**SUBJECT: Transmittal of Revised Responses to AP1000 DSER Open Items**

**AP1000 Design Certification Review  
Draft Safety Evaluation Report Open Item Responses**

**DSER Open Item Number: 2.5.4-2 (Revision 2)**

Figure 3.7.2.9-1-1: Node 532 – FRS comparison - Y Direction

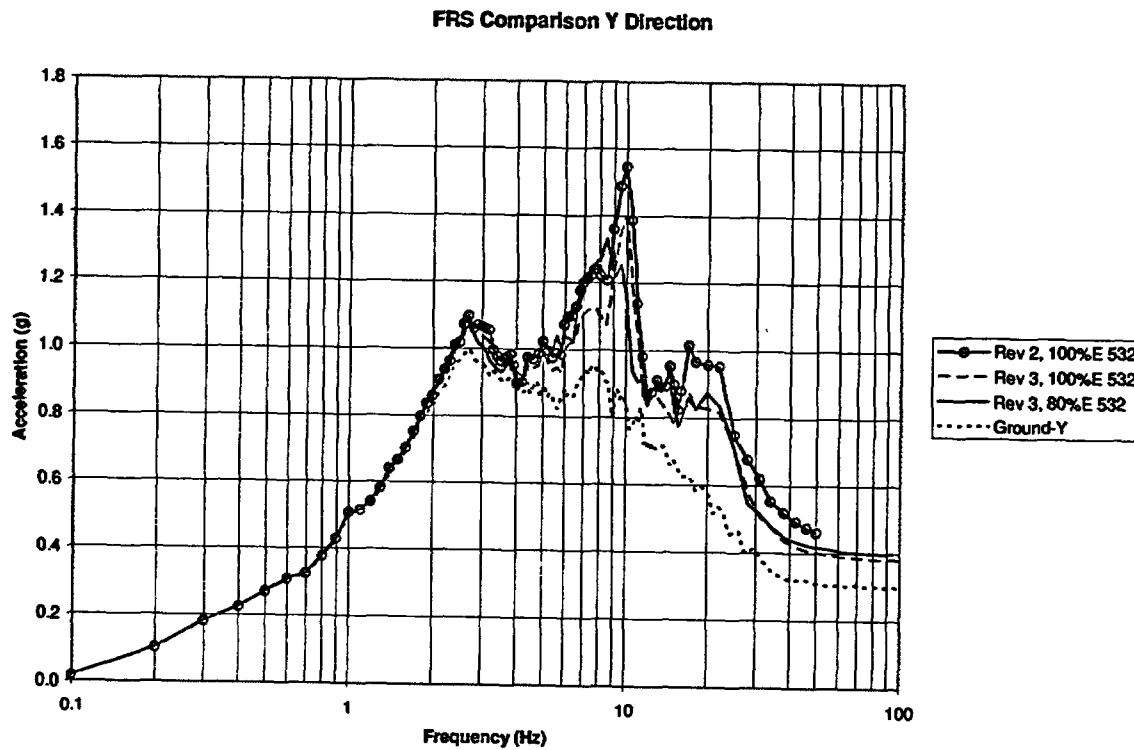
As described in DCD Tier 2 Section 3.7.2.9, as part of accounting for parameter uncertainty, Westinghouse in its response to DSEI Open Item 3.7.2.3-1 shows floor response spectra which include the effects of stiffness reduction due to shear wall concrete cracking. In comparing the floor response spectra published in DCD Revision 3 which was based on uncracked concrete properties (100% E), and DCD Revision 6 which is based on partially cracked concrete properties (80% E), it is found that in most instances the 80% E analysis, shows increases in floor response spectra peaks. There are a few instances however where the floor spectra peaks have been reduced. Examples of this are the floor response spectra in the EW (Y) direction of the containment internal structures nodes 532 and 535. The staff would like Westinghouse to cite the reasons that can explain the change in the reduction at these two locations.

Figures 3.7.2.9-1-1 and 3.7.2.9-1-2 show the floor response spectra in the EW (Y) direction of the containment internal structures nodes 532 and 535. The differences between the Rev 2 100% E spectra and the Rev 3 100 %E spectra are due to a more accurate representation of the nuclear island model (including the SCV being attached to the CIS). This more accurate representation included smaller masses at these locations as well as new beam properties based on the CIS finite element model stiffness analyses. The differences between the Rev 3 100% E spectra and the Rev 3 80 %E spectra are due to change from uncracked to partially cracked concrete properties. The reduced stiffness changes cause slight changes in the nuclear island mode shapes that reduce the response in this location.

Figure 5.3-2

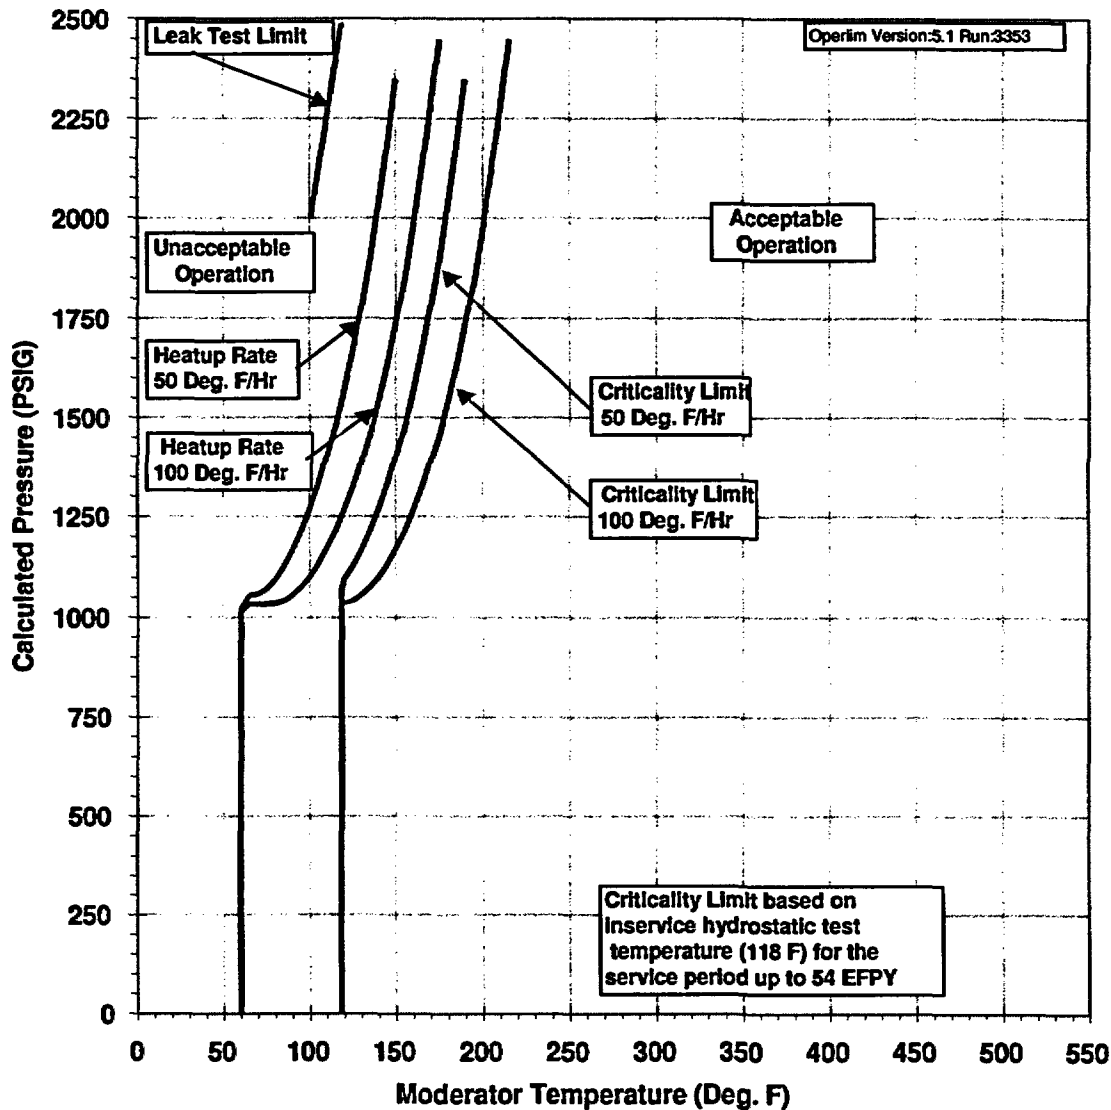
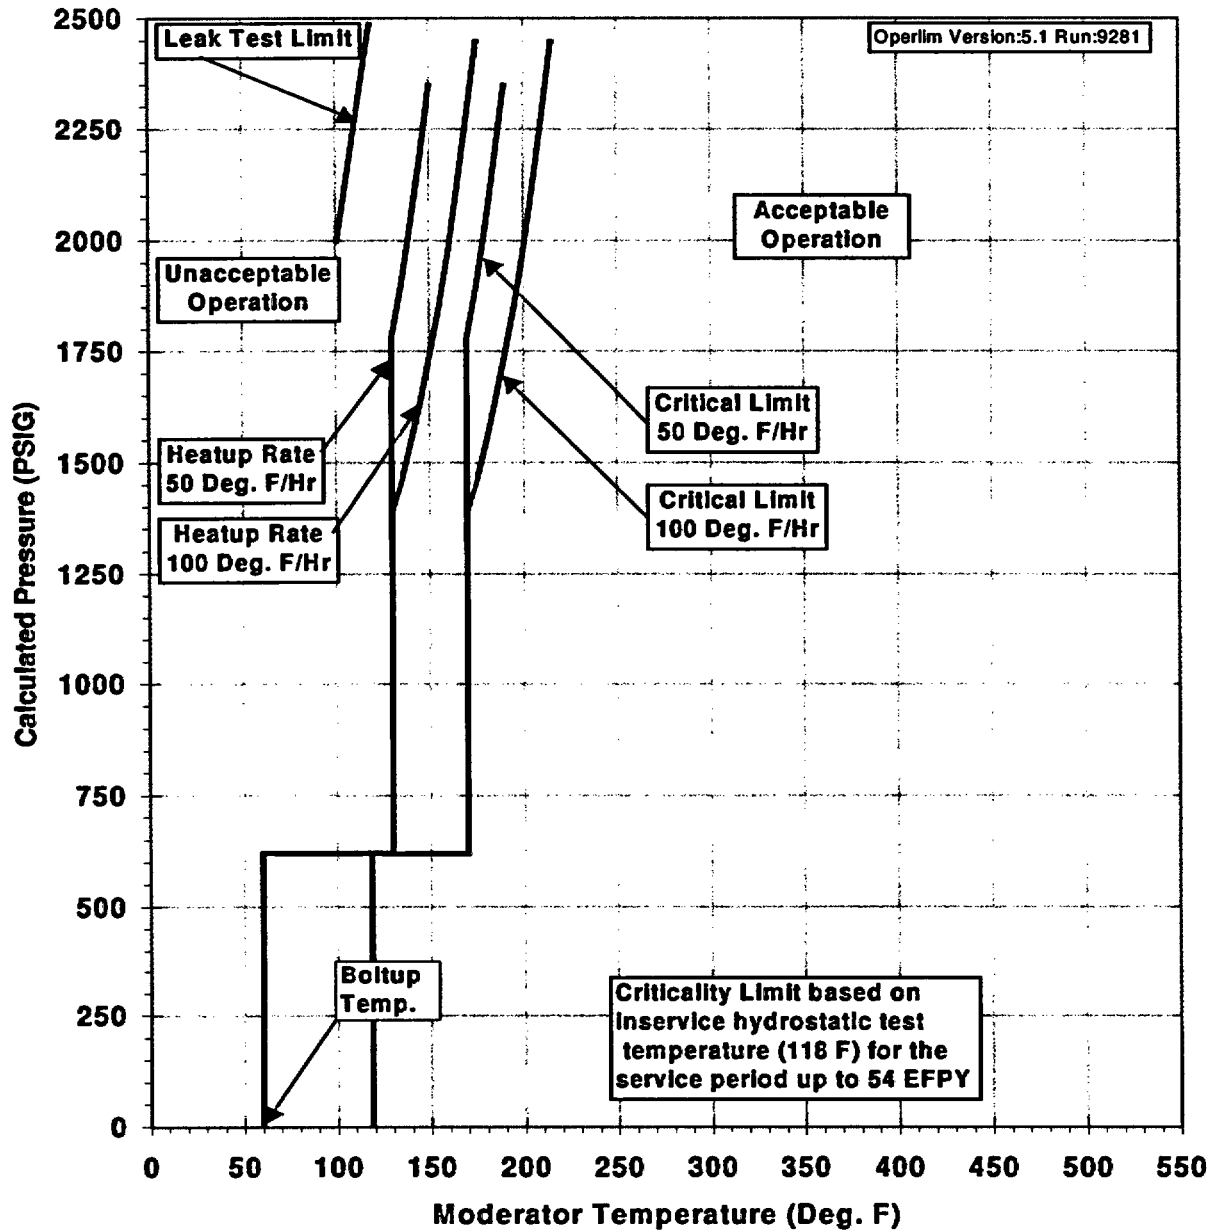
The staff requested, in RAI 251.018, that the applicant demonstrate that the P-T limits are in accordance with Appendix G to 10 CFR Part 50. The applicant responded, that the AP1000 heatup and cooldown operating curves were generated using the most limiting adjusted reference temperature values and the NRC-approved methodology as documented in WCAP-14040-NP-A, "Methodology Used to Develop Cold Overpressure Mitigating System Setpoints and RCS Heatup and Cooldown Limit Curves," with staff approved exceptions.

One exception is that instead of using best estimate fluence values, the applicant is using fluence values that are calculated fluence values. The staff finds this acceptable because this is in compliance with RG 1.190, "Calculational and Dosimetry Methods for Determining Pressure Vessel Neutron Fluence." The other exception is that the K<sub>IC</sub> critical stress intensities are used in place of the K<sub>IA</sub> critical stress intensities. This methodology is taken from staff approved ASME Code Case N-641. The staff found the applicant's responses acceptable because the AP1000 P-T limit curves were developed in accordance with 10 CFR Part 50, Appendix G, with the exception that the flange requirement is in accordance with WCAP 15315, "Reactor Vessel Closure Head/Vessel Flange Requirements Evaluation for Operating PWR and BWR Plants." Currently, the staff has not approved WCAP 15315. Any changes to the RV closure head requirements would be incorporated into Appendix G of 10 CFR Part 50. If a relaxation to 10 CFR Part 50, Appendix G is approved, this will allow the operating window to be wider. Since applicants using AP1000 are required to meet the requirements of 10 CFR Part 50, Appendix G, applicants using AP1000 must meet the closure head requirements of Appendix G of 10 CFR Part 50. However, the AP1000 DCD does not provide limitations (values of RTNDT) for the closure flange region of the RV and head. The AP1000 design must include these limitations in order to satisfy Appendix G of 10 CFR Part 50. The applicant should provide these limitations that are consistent with the present TSs and 10 CFR Part 50, Appendix G, or provide closure flange limitations with new TSs that are consistent with 10 CFR Part 50, Appendix G. This is Open Item 5.3.3-1.

Westinghouse will revise the AP1000 DCD to include P/T curves that meet the reactor vessel closure head flange requirements of 10 CFR Part 50 Appendix G. The normal RHR system relief valve setpoint and capacity will also be revised as a result of a revised LTOPS evaluation based on the new P/T curves.
